SITE PLAN REVIEW

LOT NO. 26 REGISTERED PLAN H34-2057

SCALE 1:250 			10m 5m 0m
	GREENYORK HOMES			
GRANELLI HOMES				10m 5m 0m
PROJ. No. 17-55	MUNICIPAL ADDRESS			
LOT No. 26	MUNICIPAL ADDRESS			10m 5m 0m
PLAN OF SUBDIVISION OF PART OF BLOCK 203, PLAN 43M-1677 AND PART OF BLOCK 111, PLAN 43W-1712 CITY OF BRAMPTON REGIONAL MUNICIPALITY OF PEEBLES

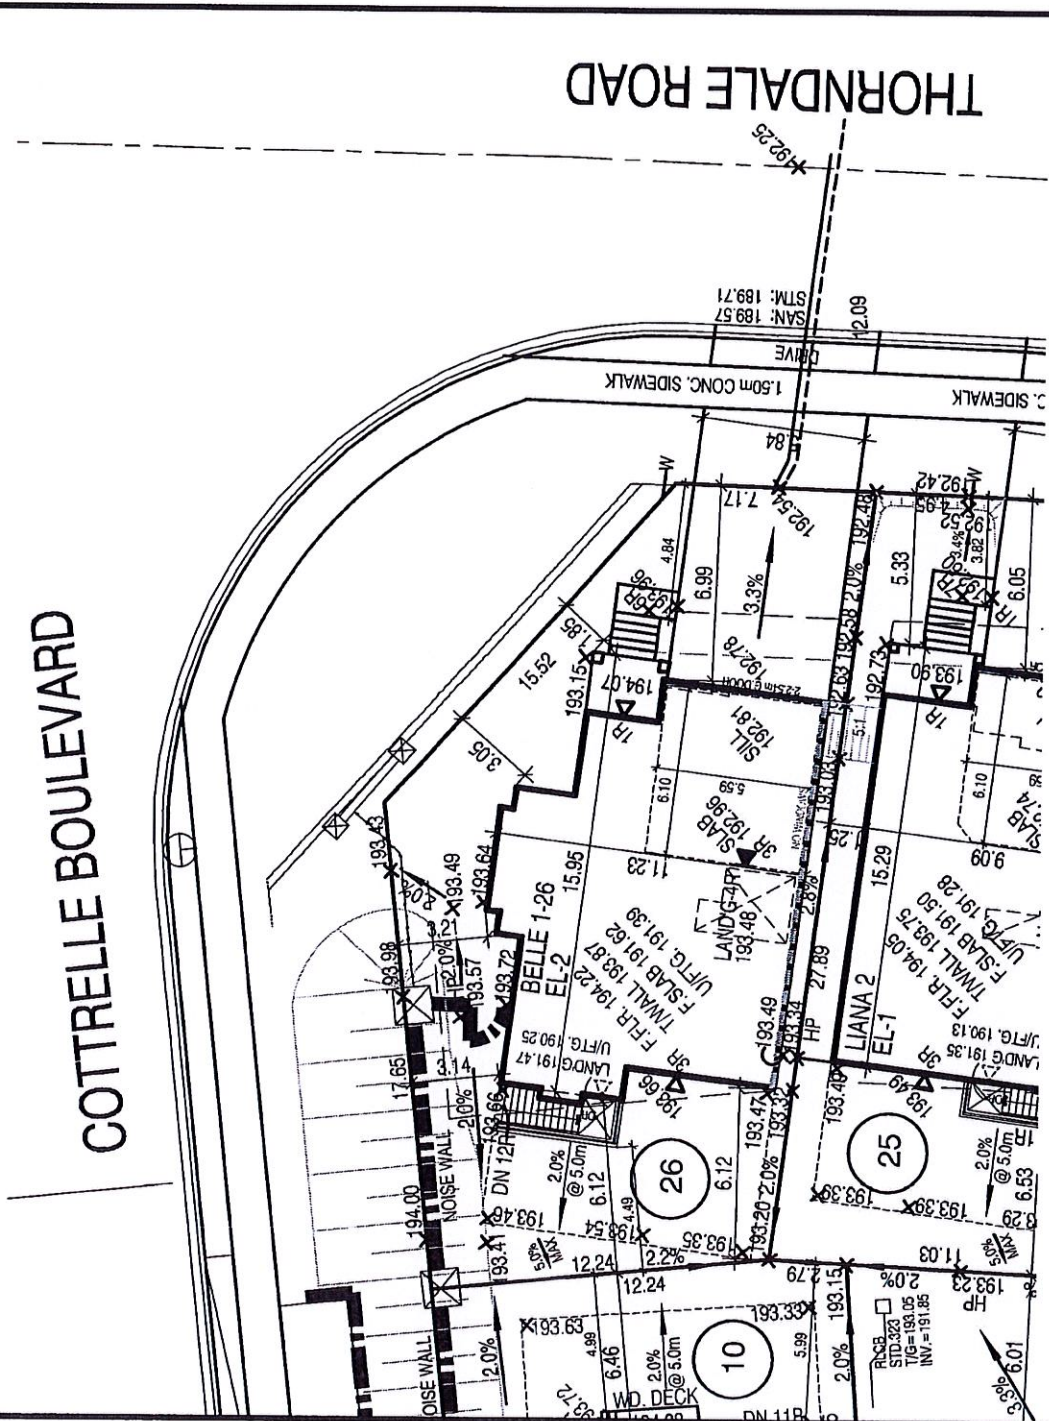
THE PROPOSED LOT GRADING AND DRAINAGE IS APPROVED
AS BEING IN CONFORMANCE WITH THE OVERALL APPROVED
GRADING PLANS FOR THE SUBDIVISION

NO COMMENT ☒ REVIEWED BY 26
